**Rezoning Plat**  
**766 and 770 Ledford Street**  
Cobb County, Georgia  
Land Lot 422, 17th District, 2nd Section

# Z-27-2017-GIS

**ZONING COMMENTS:**

## STAFF RECOMMENDATIONS

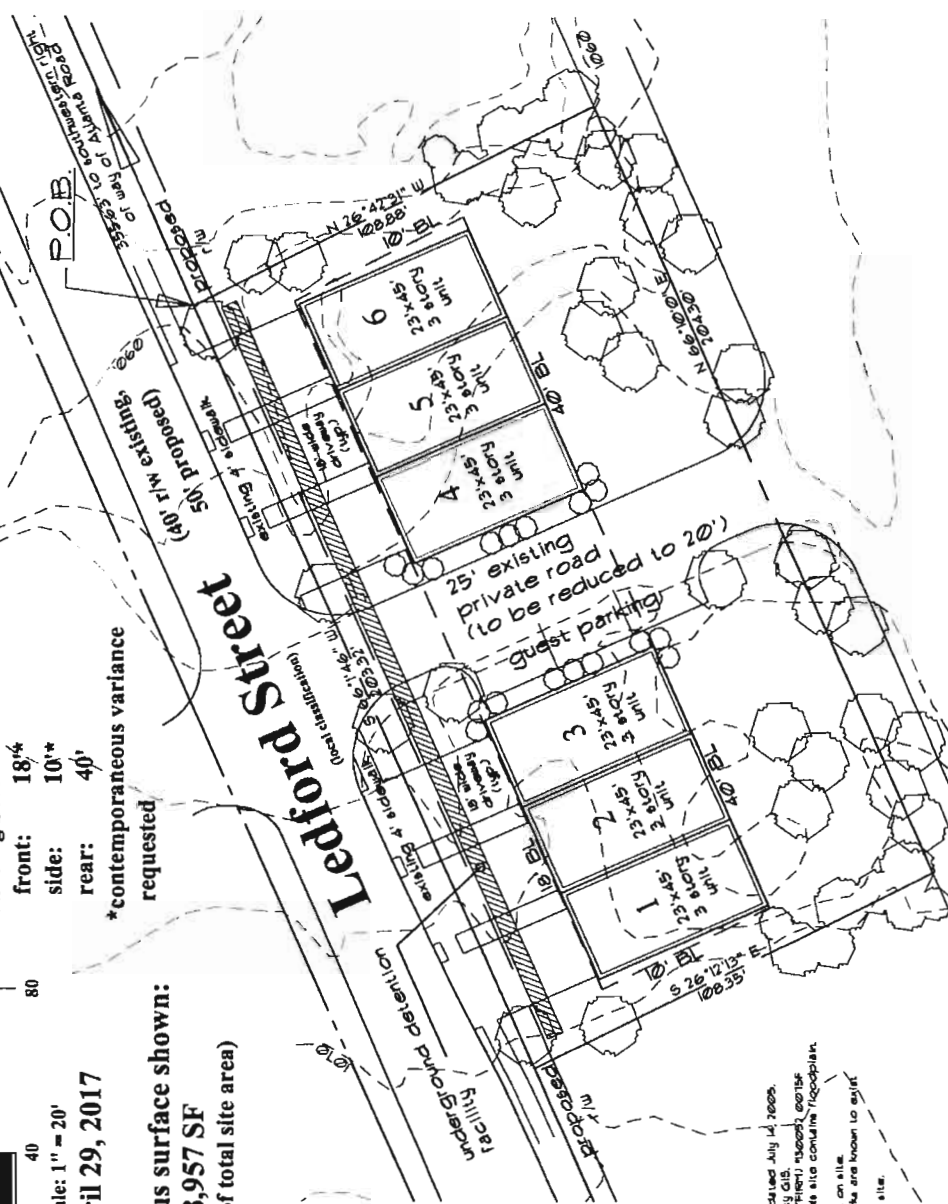
The proposed site plan will require the following contemporaneous variances;

1. Waive the minimum lot size from 80,000 square feet to 22115 square feet;
2. Waive the front setback from 50 feet to 18 feet;
3. Waive the side setbacks from 35 feet to 10 feet.

This project must comply with the Cobb County Tree Ordinance. Full compliance may be difficult to achieve due to the total amount of proposed impervious surface, along with the lack of natural/landscaped areas. Applicant should consider reducing the number and/or size of the proposed units.

- Provide comprehensive hydrology/stormwater controls to include development of out parcels.
- Submit all proposed site improvements to Plan Review.
- Any **spring activity** uncovered must be addressed by a qualified geotechnical engineer (PE).
- Structural fill \_\_\_\_\_ must be placed under the direction of a qualified registered Georgia geotechnical engineer (PE).
- Existing facility.
- Project must comply with the Water Quality requirements of the CWA-NPDES-NPS Permit and County Water Quality Ordinance.
- Water Quality/Quantity contributions of the existing lake/pond on site must be continued as baseline conditions into proposed project.
- Calculate and provide % impervious of project site.
- Revisit design; reduce pavement area to reduce runoff and pollution.

Ledford Street is classified as a local and according to the available information the existing right-of-way does not meet the minimum requirements for this classification.

Recommend applicant consider entering into a development agreement pursuant to O.C.G.A. 36-71-13 for dedication of the following system improvements to mitigate traffic concerns: a) donation of right-of-way on the south side of Ledford Street, a minimum of 25' from the roadway centerline.

Recommend curb, gutter, and sidewalk along the Ledford Street frontage.

- A. It is Staff's opinion that the applicant's rezoning proposal will not permit a use that is suitable in view of the use and development of adjacent and nearby properties. This property is accessed from Ledford Street via Atlanta Road. Ledford Street has more of an industrial and commercial character view, with uses that include a welding shop and an automotive repair shop.

- B. It is Staff's opinion that the applicant's rezoning proposal may have an adverse effect on the usability of adjacent or nearby property. The apartment complex south of the property was built in 1968 and is grandfathered. The other existing nonresidential uses have the potential to be noisy and a new residential use would likely result in complaints on the existing businesses.

- E. It is Staff's opinion that there are existing and changing conditions affecting the use and development of the property which give supporting grounds for denying the applicant's rezoning proposal. Although this request is contiguous to an existing multifamily use, this property would be better suited for a light industrial use. The apartment complex was built in 1968 and is considered grandfathered. All other existing uses on the street are industrial in nature and staff is concerned that placing residential directly across the street from an unscreened welding company would cause conflicts in the future.

Based on the above analysis, Staff recommends **DENIAL**.
